SUBJECT: Plants - Correction for Working Memo #92

The purpose of this working memo is to correct an error on Page 4 of Working Memo #92.

DIAGRAMMATIC PLUMBING OPTION  
FOR CROSS CONNECTION CONTROL  
OF SHELLFISH BLOWER TANKS

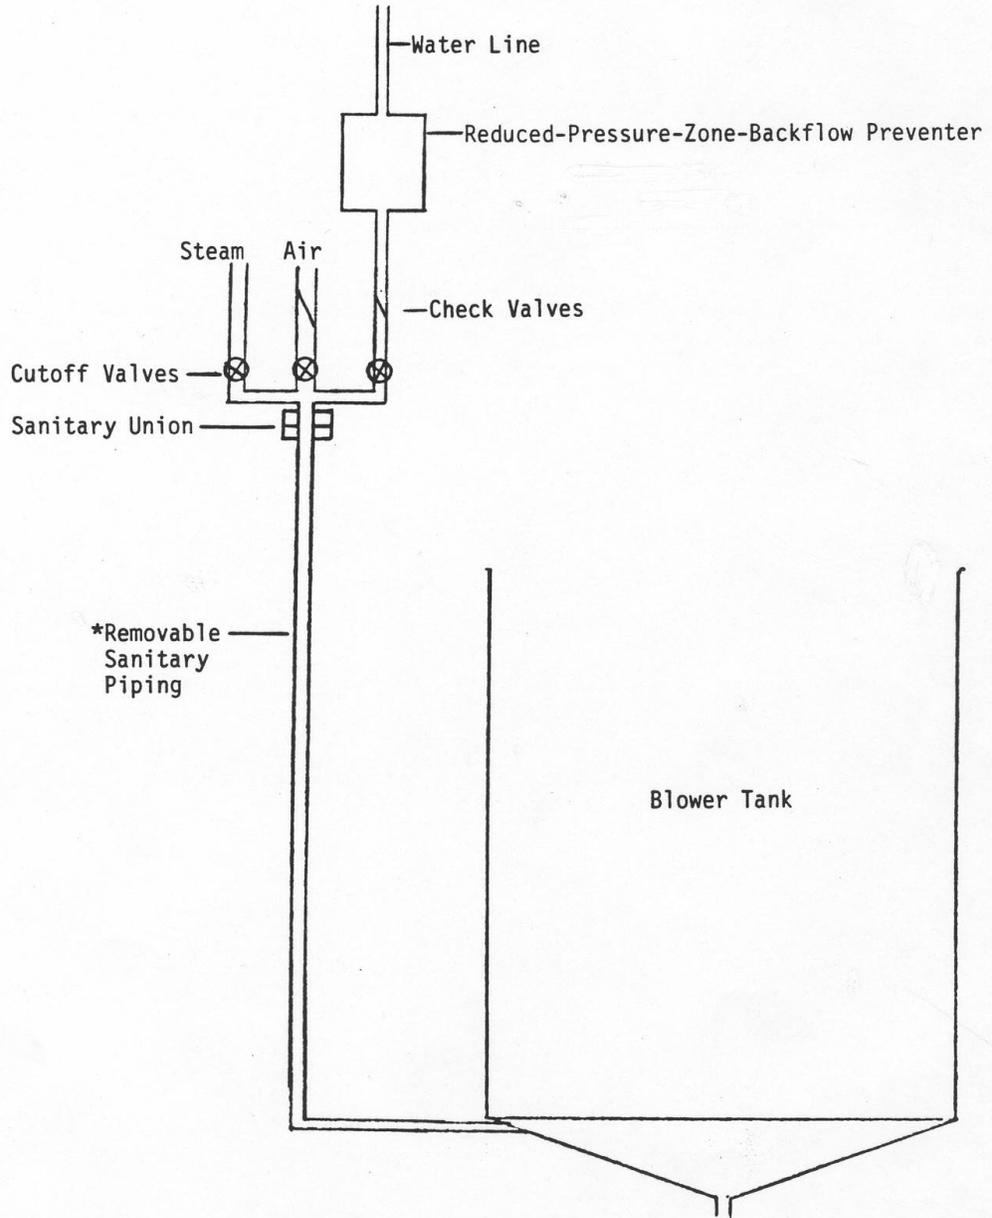
The diagram on Page 4 indicates that a double gate check valve would be adequate protection on a blower tank with a submerged inlet. This is not correct; only an RPZ is acceptable. Noncommunity waterworks must conform to ASSE 1013; private supplies and connections may conform to either ASSE 1012 or ASSe 1013 for this installation.

Remove Page 4 from Working Memo #92 and insert the attached diagram in its place. The current diagram indicates in the lower left corner that it was revised 1/89.
